Video Intercom Second Generation Indoor Station V2.0.2 Build190311 Release Note

(2019-03-11)

Firmware Version	Indoor Station: V2.0.2_190311	
Device Model: DS-KH8350-WTE1	SDK Version	HCNetSDK V5.3.6.40_build20180913	
DS-KH8350-TE1	iVMS4200 Version	V2.7.1.3build20190121	
DS-KH6320-WTE1	Hik-Connect APP	IOS 3.7.1.181228	
DS-KH6320-TE1	HIK-Connect APP	Android 3.7.1.0125	
DS-KH8520-WTE1	Batch tools	V1.0.1.8build20190114

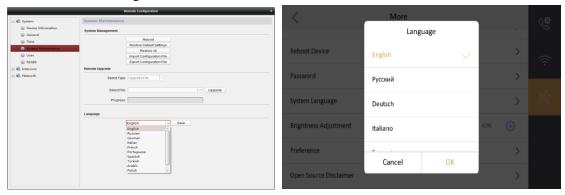
- 4.2) the indoor station supports modifying the IP of the activated door machine. It can be manually modified or DHCP. (only support using DHCP for modular door station, H5/H2/H0 (First Generation) door station don't support)
- 4.3) Indoor extension supports searching for main indoor station in the same LAN. It does not support activation, modification of IP, synchronization language, or full restoration of default parameters.

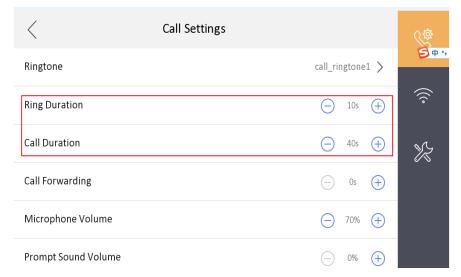
- 3. New GUI design, clear and easier.
- 4. Display room number / extension number on local interface.

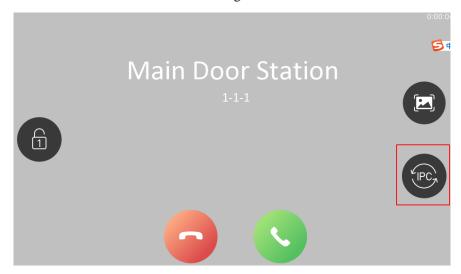
- 5. Support setting ring duration and call duration separately.
 - 1) The ring duration is indoor station ringing time and the call duration is total call waiting time.
 - 2) Ring duration: 0~60s, Call duration: 30~60s. Ring duration must be shorter than call duration, otherwise, the parameter cannot be saved.
 - 3) Indoor extension's call duration is determined by main indoor station.

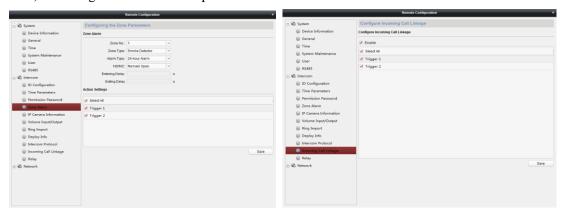
- 10. Indoor extension supports call records function
 - 1) Extension supports saving call records, and supports up to 200 records.
 - 2) The indoor extension call record supports deletion, emptying, and supports callback to the main indoor station, indoor extension, and master station.

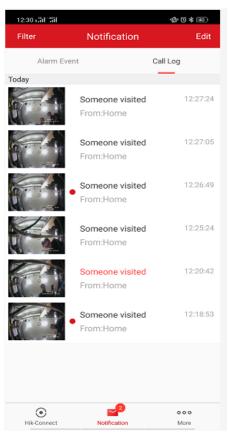
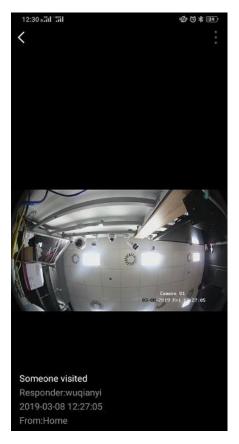
14. Support change time locally, time range: 2000-1-1 00:00 ~ 2037-12-31 23:59

16.Account sharing:

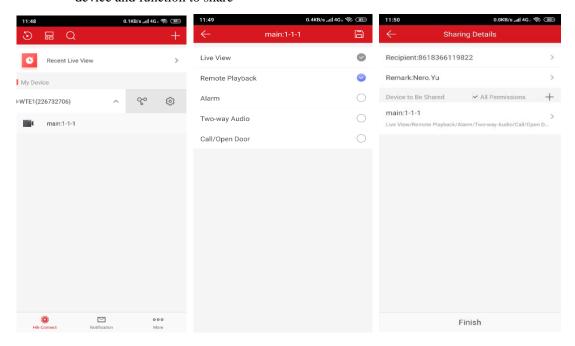
- a. Device can be shared up to 4 accounts.
- b. Main account chooses which permission can be shared, include: live view, alarm, two-way audio, call/open door (remote playback not support).
- c. Sharing steps: Open HC to enter more interfaces, then enter the "View My Sharing" interface, click "Share" button, enter the account of the shared object, select the shared device and function to share

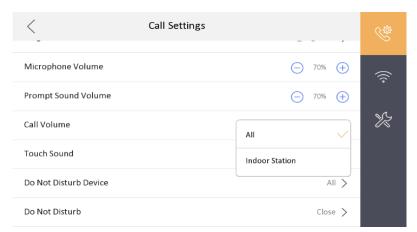
- 1. Support choose "all" or "indoor station" for "Do Not Disturb" mode.
 - 1) In DND mode, devise will not accept calls, but still save incoming call records.
 - 2) If choose "Indoor Station" for DND mode, door station/master station can still call in while other indoor station cannot call in.
 - 3) If choose "all" for DND mode, All devices cannot call in.
- 4) In standard SIP mode, only 'All' is supported, and don't support to configure for disturbing from indoor station.
